FALCON 50

WIRING DIAGRAM MANUAL

**AP/FD SWITCHINGS -
VERTICAL GYRO PRINCIPLE**

22-00-06

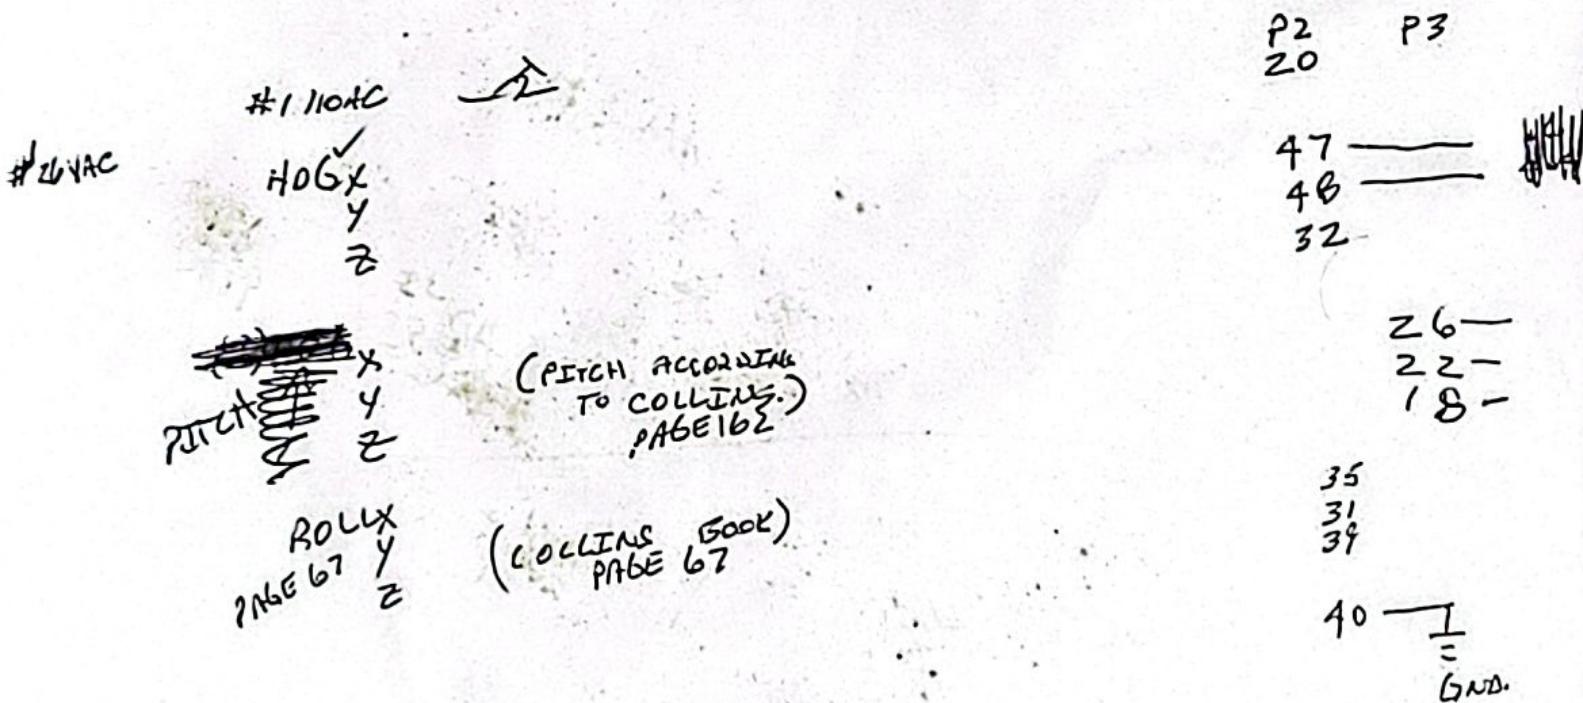
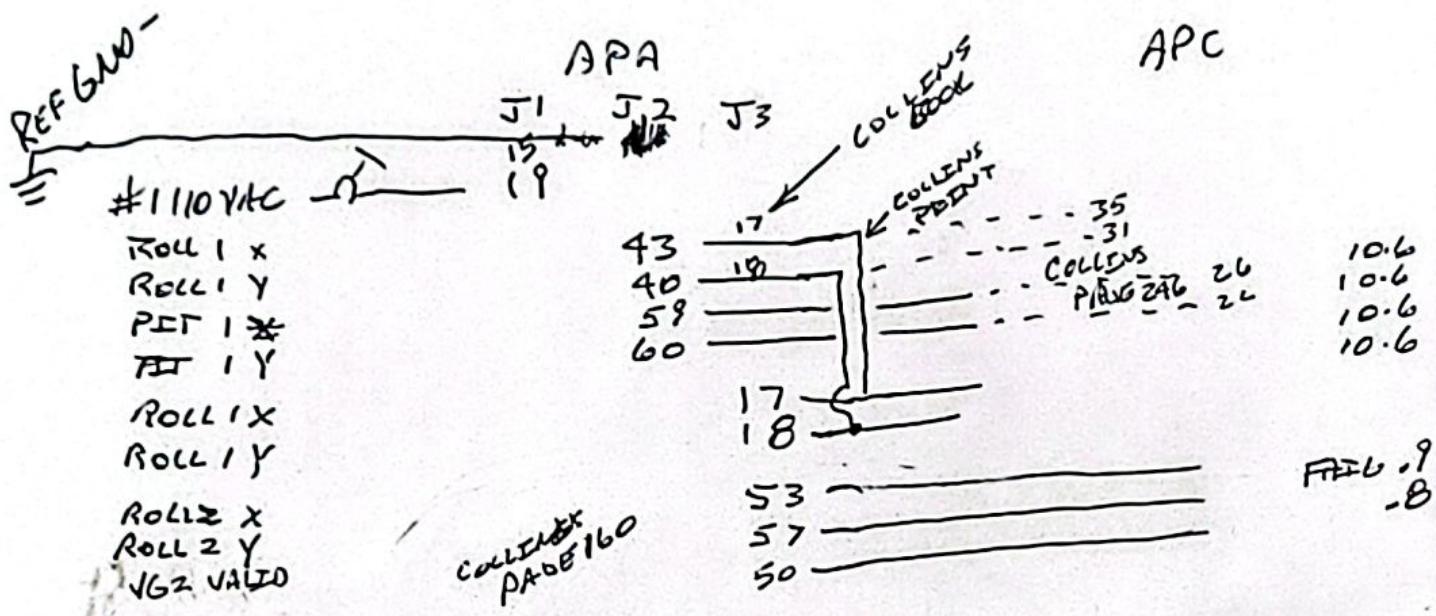
MPU 622-7254-00Z
~~C~~
~~NOT IN BOO~~

DPU 622-7248-00Z
~~C~~
=S/B 16-

WHAT [INHIBITS] COMPARATOR?

1. 20° BANK ANGLE
2. GROUND STRAP 22 AND 12 DPU
3. VG BREAKERS ALL PULLED

WHAT MAKES COMPARATOR WORK??

MUST HAVE ALL THESE

- {
1. Z UNITS POWERED
 2. LXFER CTL
 3. ONSIDE VG BREAKERS PUSHED

) THIS WORKS ONLY IN LXFER [CTL]
